Responses to Comments on Draft Revised and Recirculated Initial Study/Mitigated Negative Declaration

Big Tujunga Reservoir Restoration Project

Prepared for | Los Angeles County Flood Control District
900 South Fremont Avenue
Alhambra, California 91803-1331

October 2022

Comment ANF-1

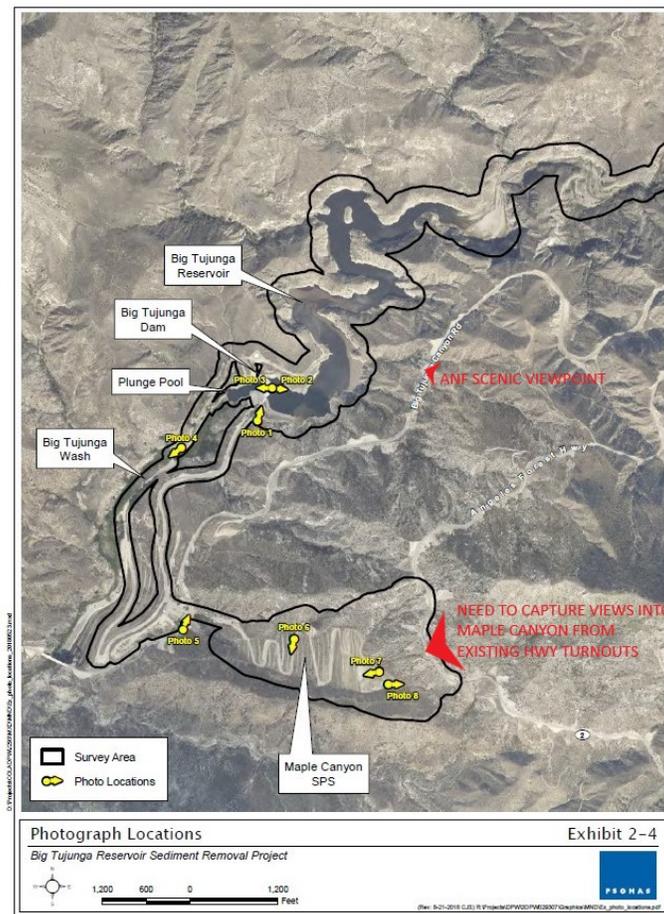
Missing photo locations are depicted by the two red arrows. Project views need to be captured and analyzed from the Big Tujunga Scenic Viewpoint that looks directly into the Reservoir, and from the turnouts along Angeles Forest Highway that are above the Maple Canyon sediment placement site.

The comment is noted and will be forwarded to the decision makers. A detailed analysis of potential visual impacts of the Project is included in Section 4.1, Aesthetics, of the Revised and Recirculated Draft IS/MND. Exhibits 2-4, 2-4A, and 2-4B of the Draft Revised and Recirculated IS/MND provide eight site photographs of views characteristic of the Project site and Project area. The discussion acknowledges views of the upstream side of the dam into the BTR from the Scenic Viewpoint along Big Tujunga Canyon Road, as identified in the comment. The discussion does indicate that the views would be available only to persons who make a stop at the Scenic Viewpoint along the road, otherwise the site would be minimally visible to drivers on the Big Tujunga Canyon Road due to the lower elevation of the BTR; the curved alignment of Big Tujunga Canyon Road in the vicinity of the BTR; and the intervening vegetation and topography. It should also be noted that the BTR has always been visible from this particular viewpoint in the existing condition. The modified condition (i.e., during sediment removal and placement activities) would include the presence of trucks, equipment, and workers at the BTR and Maple Canyon SPS, which is a temporary condition. The Project activities are necessary to allow the BTR to adequately perform its main functions of flood control and water conservation. Sediment removal and placement are parts of the process. Implementation of the proposed Project cannot be avoided, as it would maintain the function of the BTR to provide for the safety of the public. Thus, given the necessity of the Project, sediment removal activities should be an accepted condition. Additionally, it should be recognized, as discussed in Section 4.1, Aesthetics, of the Revised and Recirculated IS/MND, the removal of sediment is temporary in nature and would have less than significant impacts on scenic vistas and the visual character of BTR from the scenic viewpoint and from views along Big Tujunga Canyon Road, as identified in the comment. After completion of the Project and removal of the sediment, the bottom of the BTR would be covered by surface water and would return to its existing visual condition.

As shown in Exhibit 4-1, the U.S. Forest Service (USFS) does identify a scenic viewpoint at Big Tujunga Road. It should be noted that the commenter requested that views be captured and analyzed from a point further northeast than the scenic viewpoint identified by the USFS in Exhibit (i.e., "ANF Scenic Viewpoint" within comment letter). Additionally, as shown on Exhibit 4-1, the USFS does not indicate a scenic viewpoint at the location provided by the commenter (i.e., east of Maple Canyon SPS). In terms of views of the Maple Canyon SPS, they are only available to vehicular activity along a portion of the Angeles Forest Highway, which is located approximately 650 feet from the top of the eastern end of Maple Canyon SPS, as detailed on page 4-5 of the Draft Revised and Recirculated IS/MND. No direct views of the SPS are available as the SPS is located lower than the road. There are no designated hiking trails within, or public access to, Maple Canyon SPS or BTR. It should also be noted that views of the sediment placement activities would be temporary, and upon completion, the revegetation plan to be approved by the U.S. Forest Service would restore biological function to the hillsides and reduce visual impacts, in addition to control erosion at the SPS.
